TECHNICAL EVALUATION REPORT FOR MLRS PIPING  
RESPONSE ANALYSIS TECHNIQUE FOR LONG TERM  
SERVICE SEISMIC REEVALUATION: SAN ONOFRE  
NUCLEAR GENERATING STATION UNIT 1

June 1985

The U.S. Nuclear Regulatory Commission

Fig. 2 The Secondary Piping System for Test Problem

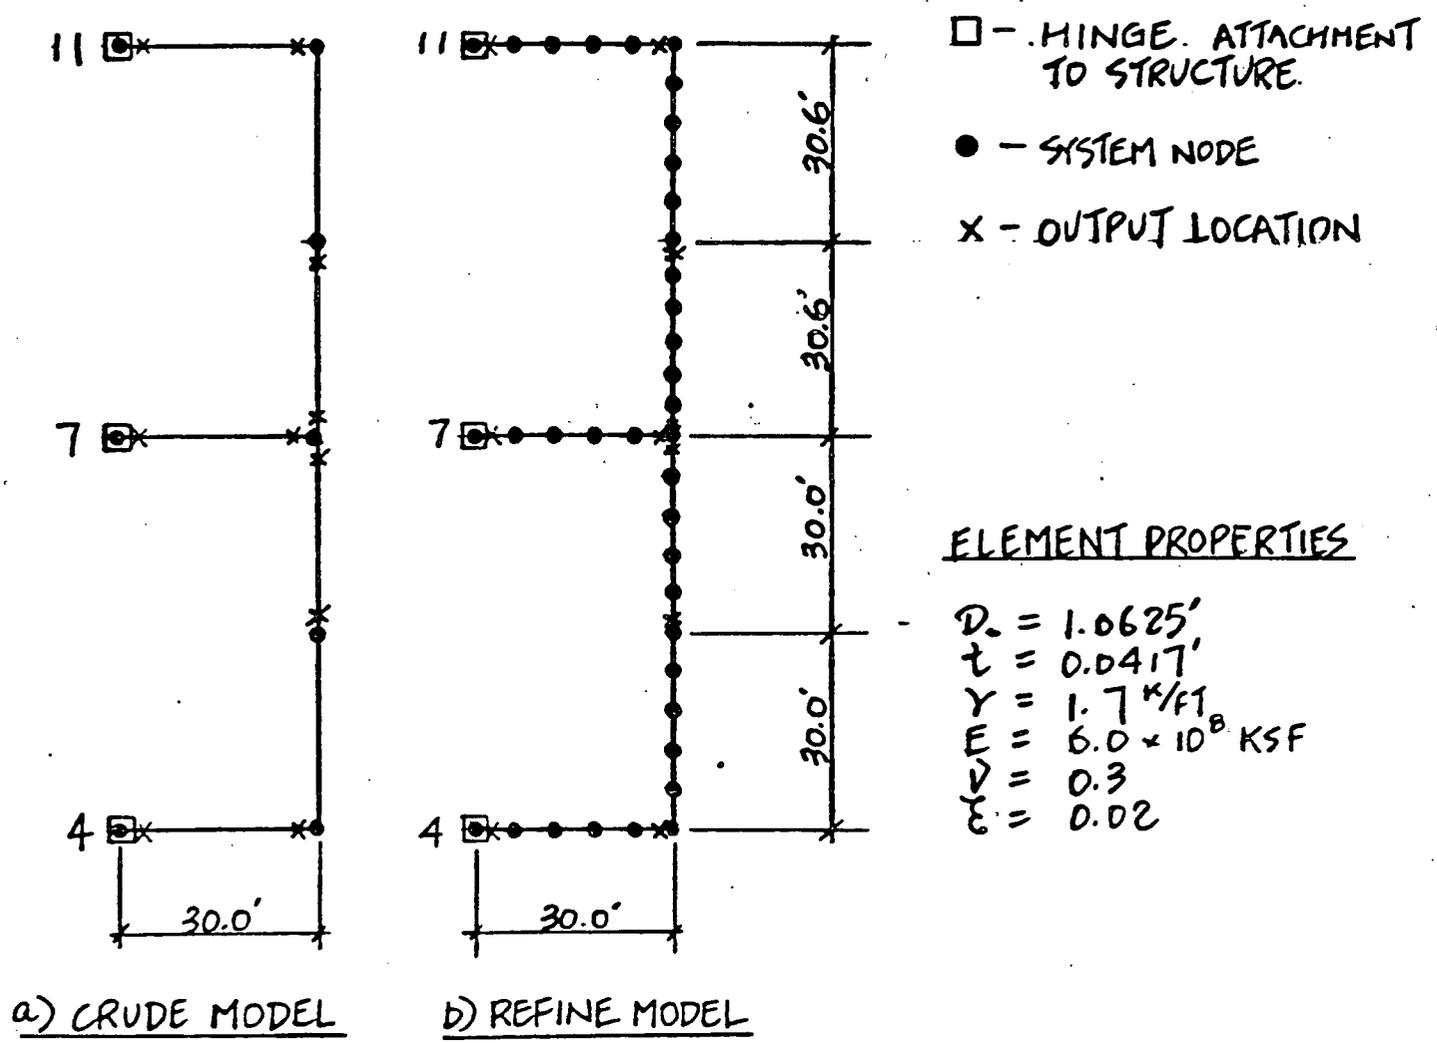
For this test problem, the licensee is required to calculate the piping moments at the ten locations specified in Fig. 2 and the axial forces in all three horizontal pipe elements connecting the piping to the supporting structure. The structure is subjected to a horizontal ground input in terms of a set of ground response spectra. The support level spectra needed for the analysis of the piping systems are generated from the ground spectra by the FLORA computer code based on the  $M_{iK}$  parameters calculated by hand.

It can be seen from Tables 1(a) and 2(a) that the licensee's results are much higher than those of time history approach. Note that the comparison is based on total seismic response (sum of inertial and pseudostatic response) since the coupled structure-piping model was analyzed through the time history method (NCT). For a coupled model it is difficult, if not impossible, to separate inertial response from the total response. In Table 1(b), for the crude model, the pipe support loads of the licensee's results are still higher than that of the time history results, even though the margins are not as much as that of piping moments. The margins of conservatism of the pipe support loads from the licensee's results are further reduced for the refined model as shown in Table 3(b). Closely examining the trend of response from the crude model to the refined model, we find an inconsistency between the NCT time history and the licensee MLRS analysis, except in the two locations at the center of the two vertical spans. The cause of this inconsistency is still unknown.

Based on our review of the licensee's proposed methodology and Reference 3, and the results from the test problem, we conclude that the application of the FLORA generated spectrum to the piping analysis appears to be sufficient. However, we could not reach any conclusion on the SUPERPIPE multiple level response spectrum method of analysis using the Regulatory Guide 1.92 modal and directional combination techniques due to the inconsistent response trend from the crude to the refined model between the NCT results and the licensee's.
